BCA and Access Report

The Palms Eatery

327 Mona Vale Road, Terrey Hills

Revision Number:	1.0
Revision Details	Report issued for submission to Council
Date:	Tuesday, 14 November 2023
Revision Number:	2023/2643 – BCA / Access – R1.0
Revision Details	Report issued for submission to Council
Date:	Wednesday, 21 February 2024
Author:	Jarryd Beckman – Unrestricted Certifier – BDC 3126  Access Institute <small>Qualified Access Consultant</small>
Verifier:	Guiseppe Graziano Unrestricted Certifier – BDC 0144

Figure 4 – External staircase location

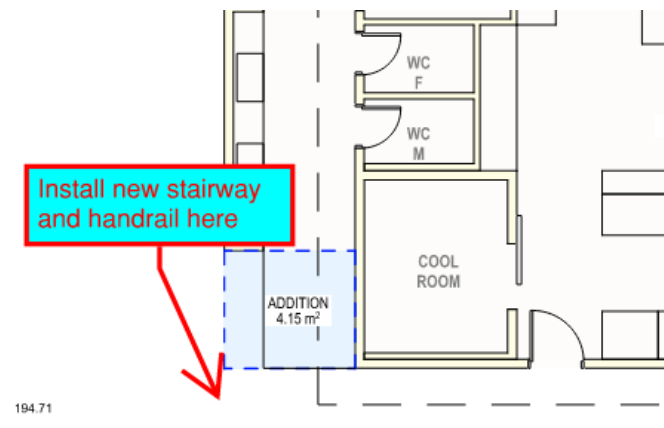
The exit from the rear kitchen area will require a new external staircase and handrail to be installed in accordance with Clause D2D15. The staircase must include non-slip nosing strips across each stair tread.

3. Install a new external egress stair at the rear of the building in accordance with Clause D2D15. Note: this will require a handrail and nosing strips.

Figure 5 – Ambulant compartment requirements

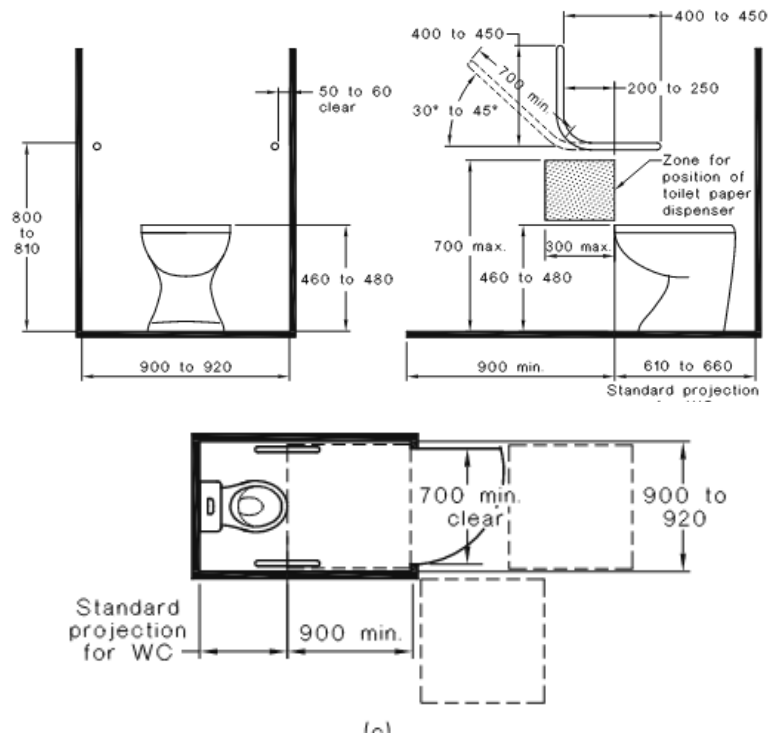
With regards to the male and female ambulant compartments, upgrades will be required to ensure compliance with Clause 16 of AS 1428.1-2009 (see below figures to assist with compliance)

9. Upgrade the existing accessible sanitary compartment to ensure compliance with AS 1428.1-2009
10. Upgrade the male and female sanitary compartments to ensure they are constructed as ambulant compartment in accordance with AAS 1428.1-2009.
